Access Compliance Report

Public Rights-of-Way

Intersection ID: 30360	Main Street: TIMBERTOP_LN	Cross Street: WORLEY_DR	Location: NW
ADA ID: 24F4524B9CB4	Ramp Type: BlendTrans1	Initial Pass/Fail: Fail	Overall Compliance: No
			Severity Score: 33.75

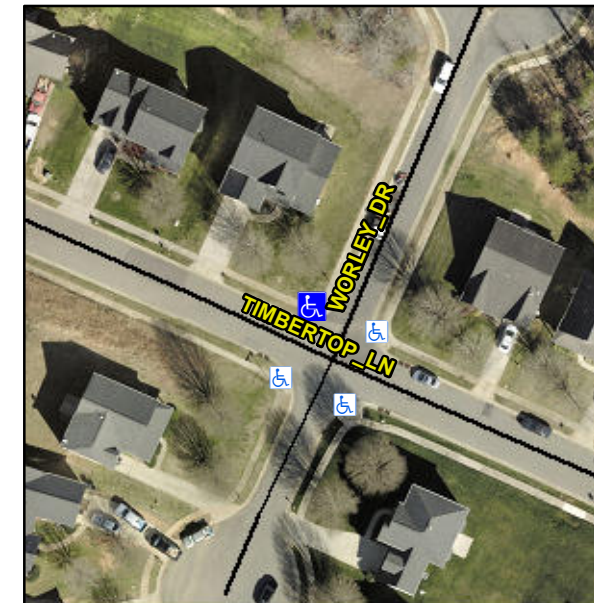
Not Found, R304.5.1, R304.5.3

Compliance	Description	Data	Compliance	Description	Data
N/A	Ramp Length (in)	49.0	Yes	BlendTrans Slope (%)	4.7
No	Ramp Width (in)	47.0	No	BlendTrans XSlope (%)	12.9
N/A	Flare Type LT	N/A	N/A	Flare Type RT	N/A
N/A	Flare Slope LT (%)	N/A	N/A	Flare Slope RT (%)	N/A
N/A	Flare Traversable LT?	N/A	N/A	Flare Traversable RT?	N/A
N/A	Landing Length (in)	N/A	N/A	DWS Provided?	N/A
N/A	Landing Width (in)	N/A	N/A	DWS Contrast?	N/A
N/A	Landing Slope (%)	N/A	N/A	DWS Length (in)	N/A
N/A	Landing X Slope (%)	N/A	N/A	DWS Full Width?	N/A
N/A	Landing Curb? (Y/N)	N/A	N/A	DWS Offset (in)	N/A
N/A	Shared Landing?	N/A			
N/A	Gutter Ponding?	N/A	N/A	Gutter Slope (%)	N/A
N/A	Gutter Lip Ht (in)	N/A	N/A	Gutter X Slope (%)	N/A
N/A	Painted X Walk1?	No	N/A	Painted X Walk2?	No
	X Walk 1 Direction	To SW		X Walk 2 Direction	To SE
	X Walk 1 Width (in)	N/A		X Walk 2 Width (in)	N/A
	X Walk 1 Slope (%)	3.7		X Walk 2 Slope (%)	9.2
	X Walk 1 X Slope (%)	9.3		X Walk 2 X Slope (%)	5.7

Remove & Replace Curb Ramp With Two New Directional Ramps or Equivalent.
